AGENDA PACKET

SEPTEMBER 19, 2023 MEETING

AGENDA

Tuesday, September 19, 2023

5 Proposed Side Elevation
1/4" = 1'-0"

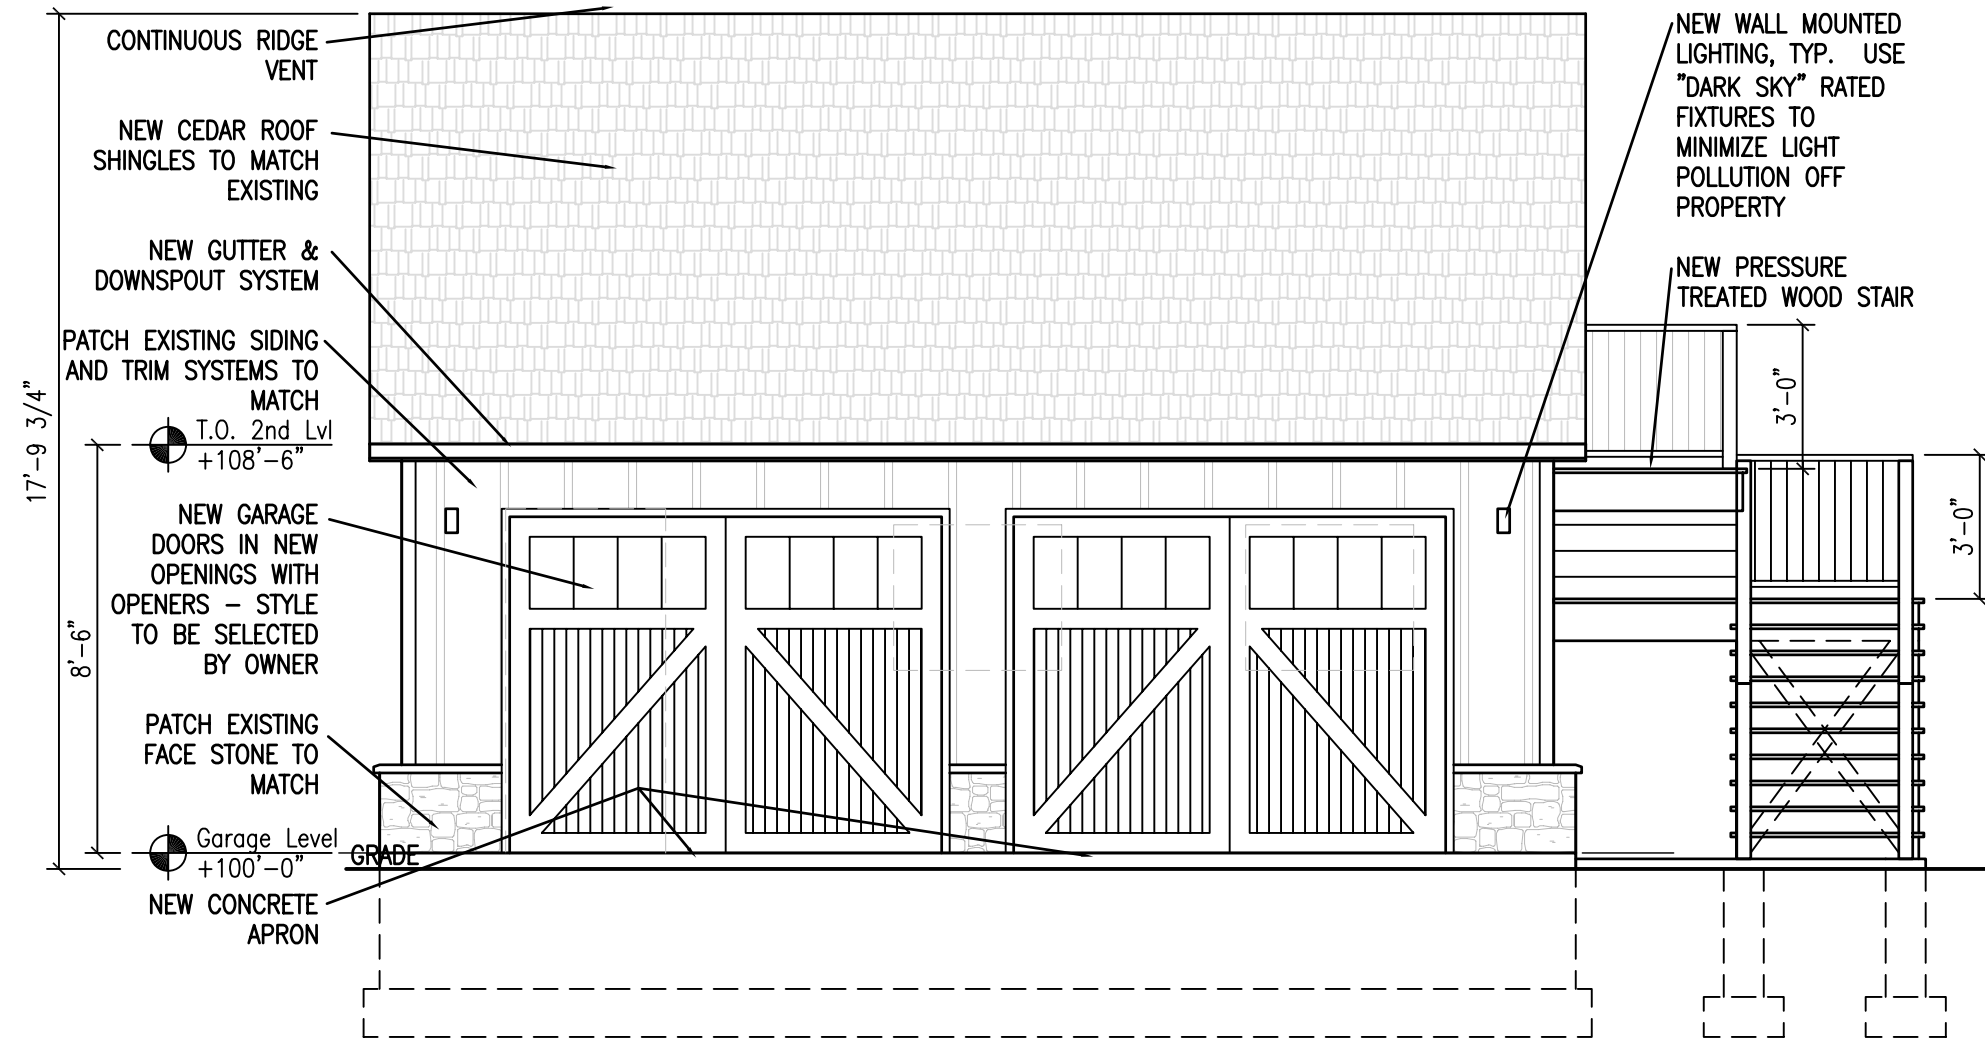
7. Regarding the building elevations sheet (Sheet A1), the side elevation (No. 5) appears to show the proposed stairs in the wrong location.
